Subject: LESHHC 03-07, Acceptance Testing for the Animal MRI Magnet

**MINUTES OF MEETING 03-07
September 16, 2003**

Brookhaven National Laboratory
Medical Department
9.4 Tesla MRI, Fill/cool-down Procedure

Figure A.1 Plotting Co-ordinate System

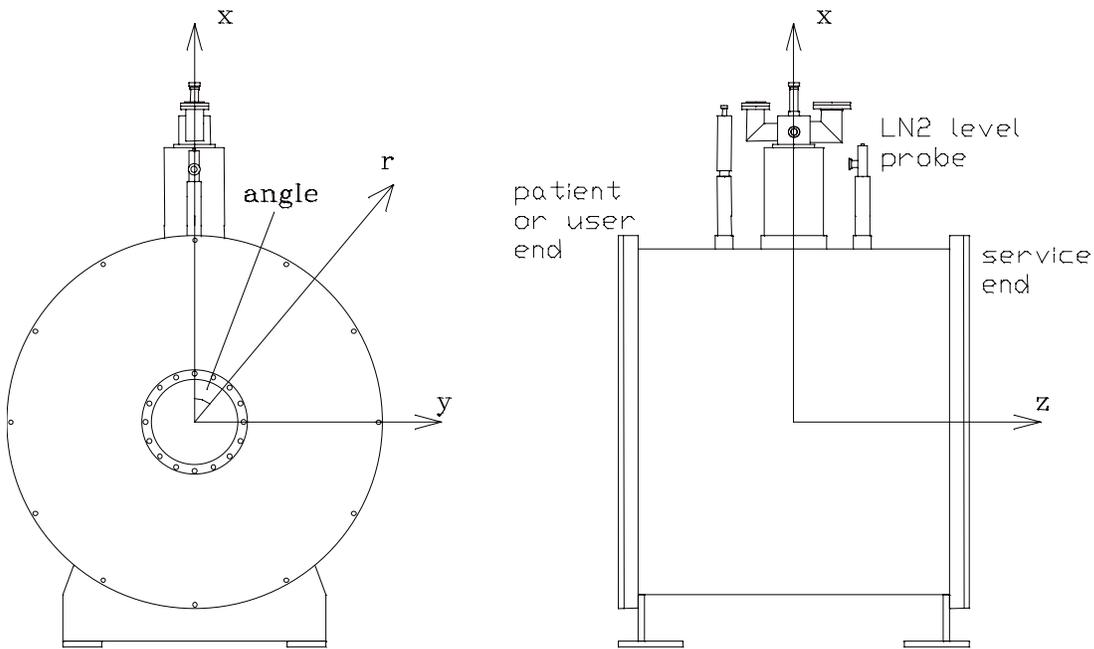
Need to update this drawing with additional coverage of shim trays and plotter orientation. Mike can complete this.
